審查意見摘要表

RESPONSES TO ROC-AEC's PSAR QUESTIONS

Figure 11.4 - 1 SRWPS Process

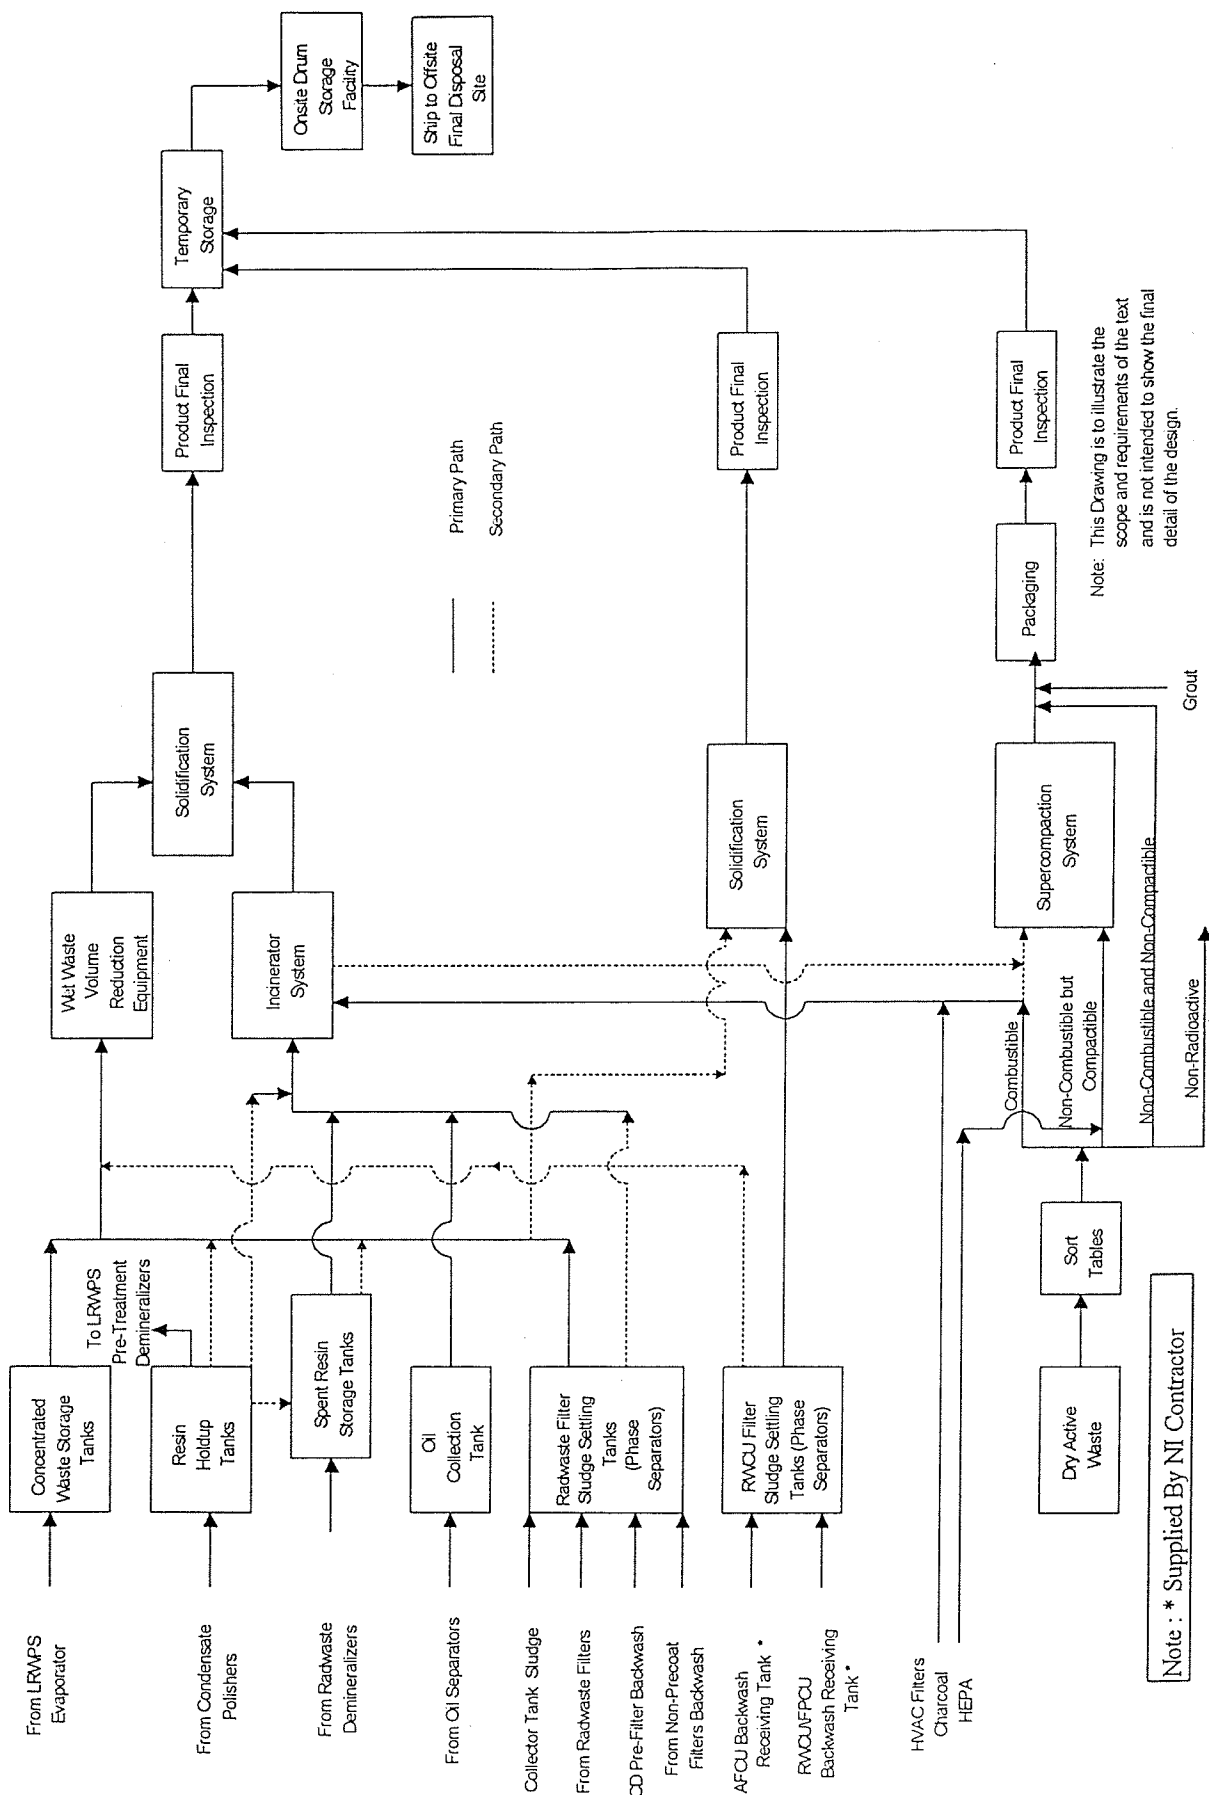
4. In page 11.4-20 Figure 11.4-1, the secondary path is incomplete, also does not specify when it will be used.

1. In Figure 11.4-1 (SRWPS Process Flow), It did not specify the liquid process design and indicated if there is any liquid existed in the process? For example, if any water is required for the incinerator (quench). Please specify the flow quantity, chemical contents of the liquid, where and how this liquid will be delivered and handled.

1. See Attachment F-11-004-1.
No changes will be made to the PSAR as a result of the response to the question.
2. See Attachment F-11-004-1.
No changes will be made to the PSAR as a result of the response to the question.
3. The PSAR section contains a typographical error and should be changed from 25Gy/h to 25 μ Gy/hr.
4. Fig 11.4-1 has been updated as attached to address this issue. The design provisions of secondary path are for operation flexibility to provide additional treatment route or backup of normal treatment

Fig 11.4-1 will be added to this PSAR section.

1. Water associated with resin transfer will be decanted to the LRWPS HIGH Purity Waste Subsystem as depicted in figure 11.2.1 Any liquid associated with the incineration process, whether quench or scrubber waste, will be forwarded to the LRWPS Low Purity Waste Subsystem as depicted in Figure 11.2.2. The actual process quantities and flow paths will be supplied with the FSAR subsequent to Radwaste System procurement.
2. Process flow Diagrams including the quantity of drum for each kind of wastes, will be provided with the FSAR subsequent to Radwaste System procurement.
